**To:** Kristopher Byrd, Well Construction and Compliance Section Manager  
**From:** Travis Kelly, Well Construction Program Coordinator  
**Subject:** Review of Water Right Application G-19004  
**Date:** September 15, 2020

Application # G- 19004

TO: Water Rights Section Date 09/10/2020
FROM: Groundwater Section Aurora C Bouchier Reviewer's Name
SUBJECT: Application G- 19004 Supersedes review of na Date of Review(s)

Map of Hole

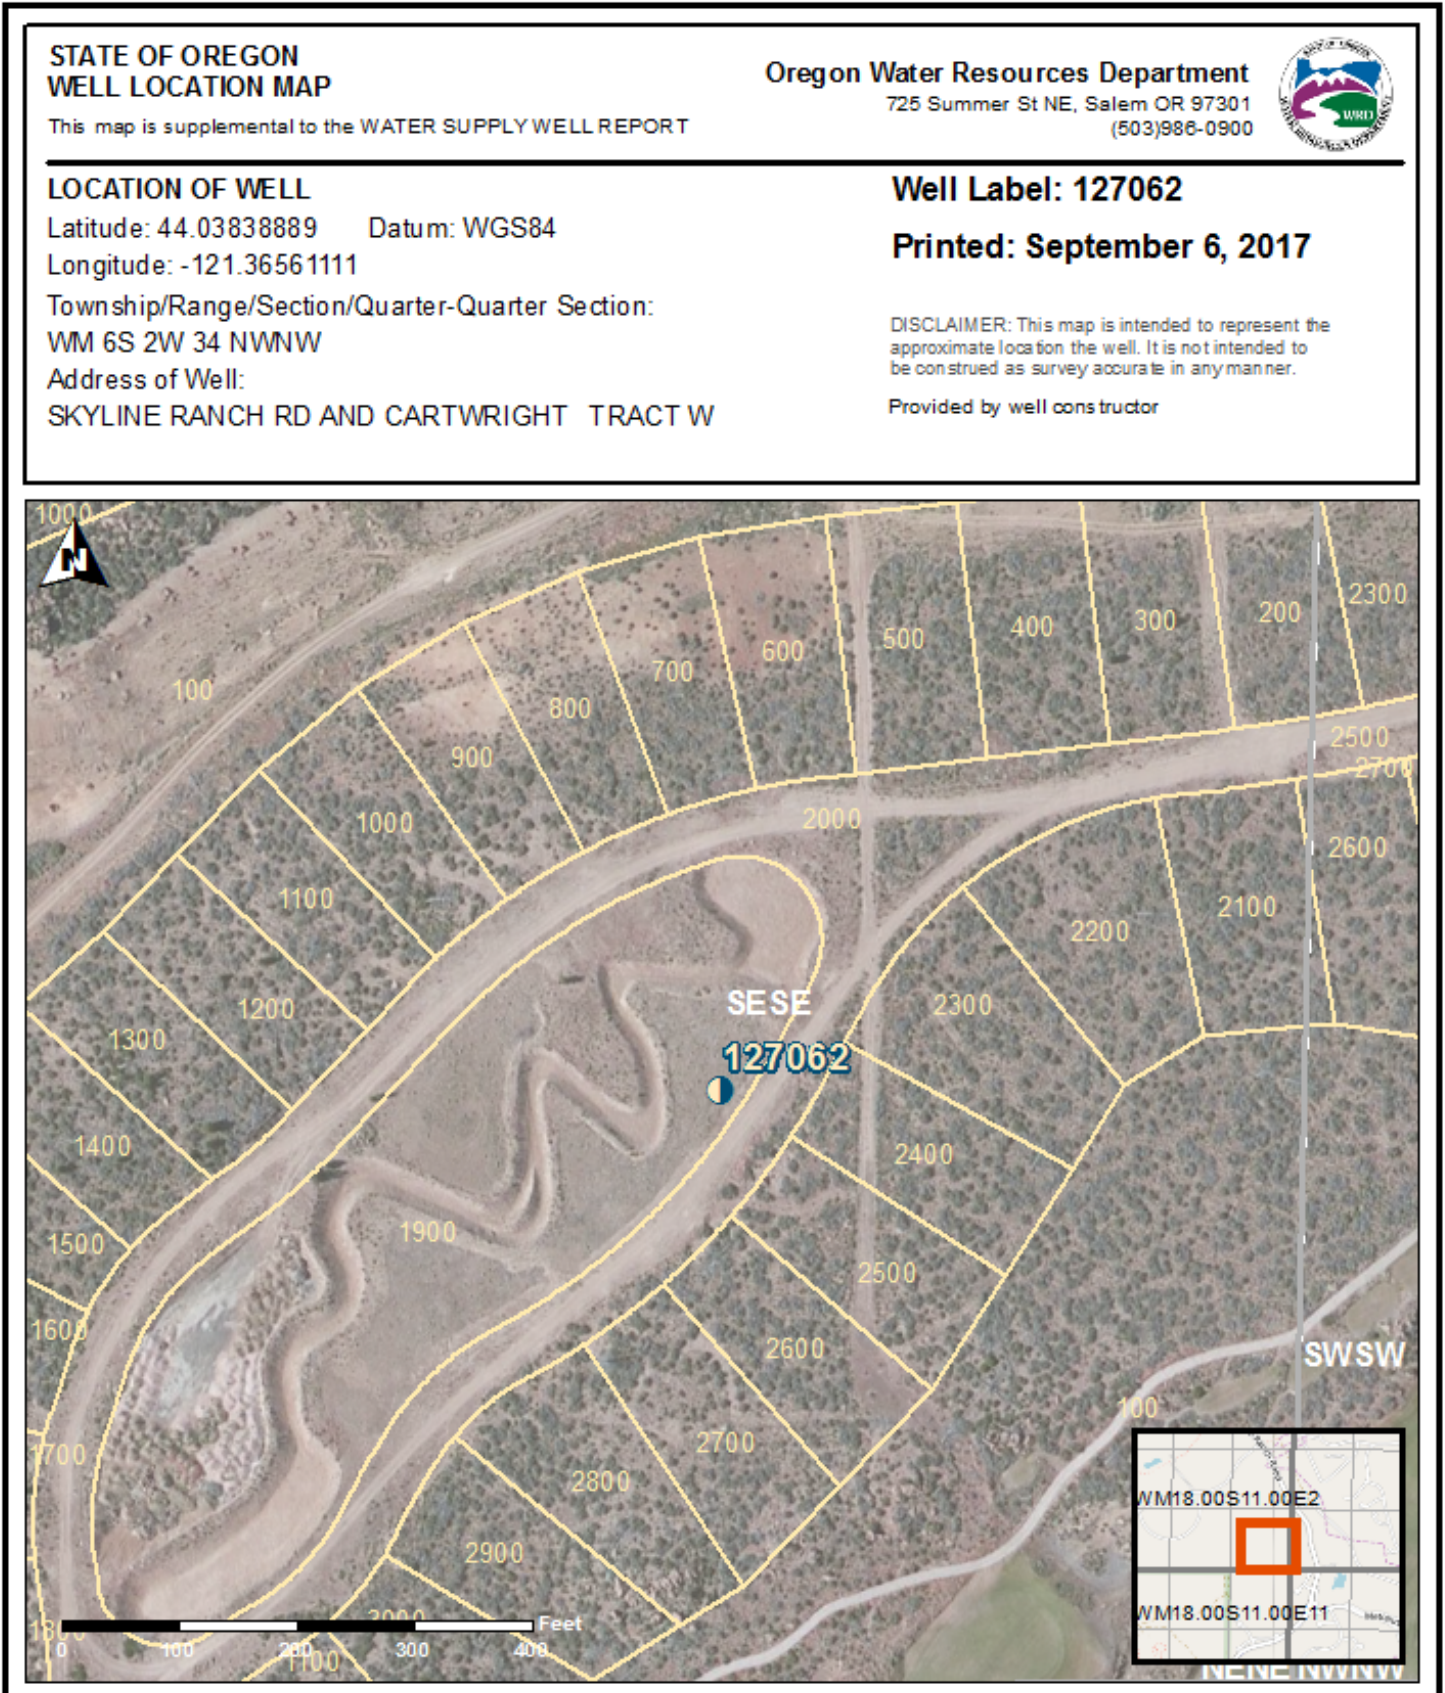
Applicant's Well #1 (DESC 61056): Based on a review of the Well Report, Applicant's Well #1 seems to protect the groundwater resource.

The proposed construction of Applicant's Well #1 may not satisfy hydraulic connection issues.

D1. Well #: 1 Logid: DESC 61056

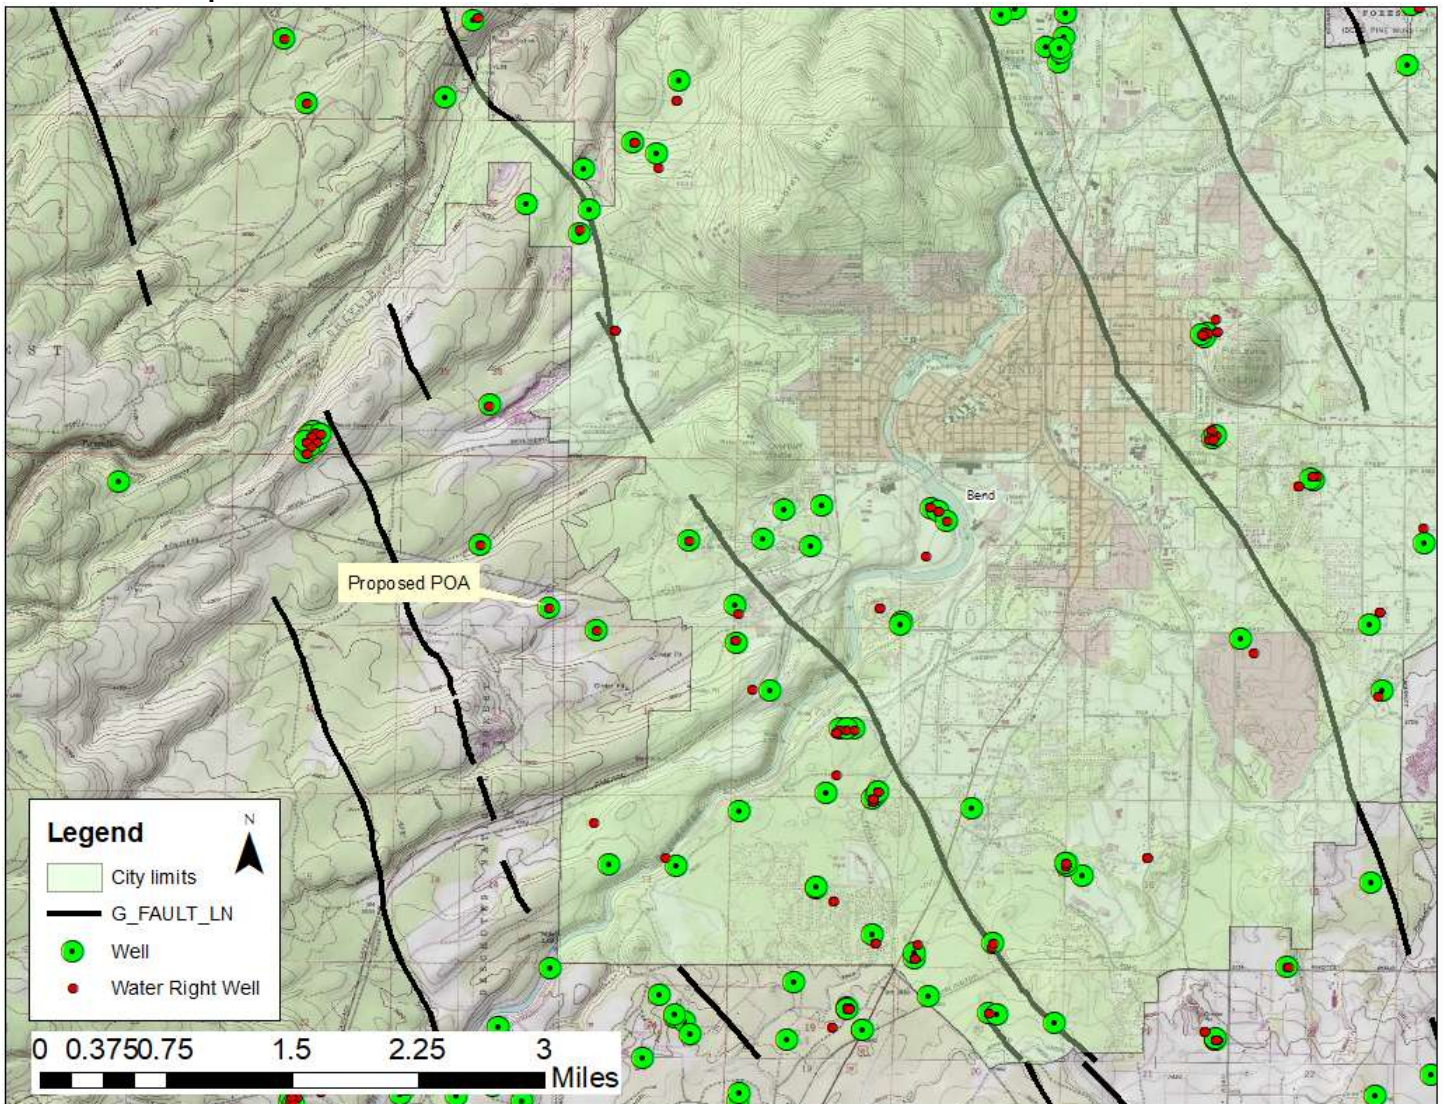
D2. THE WELL does not appear to meet current well construction standards based upon:

D3. THE WELL construction deficiency or other comment is described as follows: \_\_\_\_\_

D4.  Route to the Well Construction and Compliance Section for a review of existing well construction.

### Water-Level Measurements in Nearby Wells

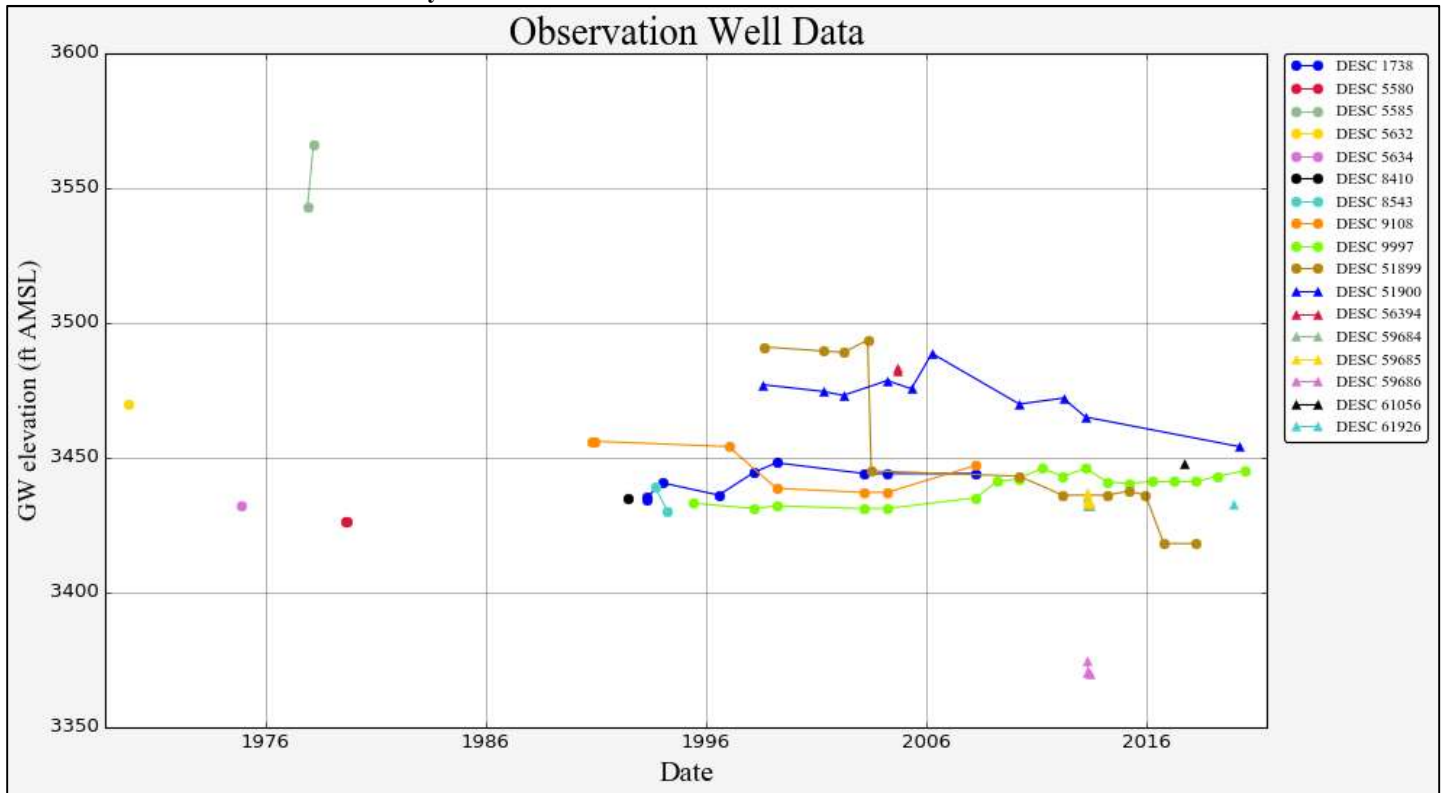
The site is located within the Sisters Fault Zone, south of Awbrey Butte. As such, relevant observation wells should be similarly located within the fault zone. Unfortunately, it appears that there are no long-term observation wells within this portion of the fault zone. The groundwater in nearby wells appear relatively stable..

For comparison sake, wells located up-gradient of the fault zones (i.e. DESC 7620 located in La Pine) continue to show a strong response to climate cycles through present. However, wells located down-gradient of the fault zones (i.e. DESC 3581 located in Redmond and DESC 5045 located in Bend) show a persistent decline since the mid 1990’s through present.

It appears that the fault zone acts to retard the propagation of the groundwater decline. It is likely that addition groundwater production within the USGS Deschutes Ground Water Study Area (DGWSA) will act to further exacerbate the groundwater declines seen down-gradient of the fault zones (Sisters and Brothers fault zones). However, the cumulative 200 cfs cap on groundwater permits has not yet been reached (Division 690-505-0500).
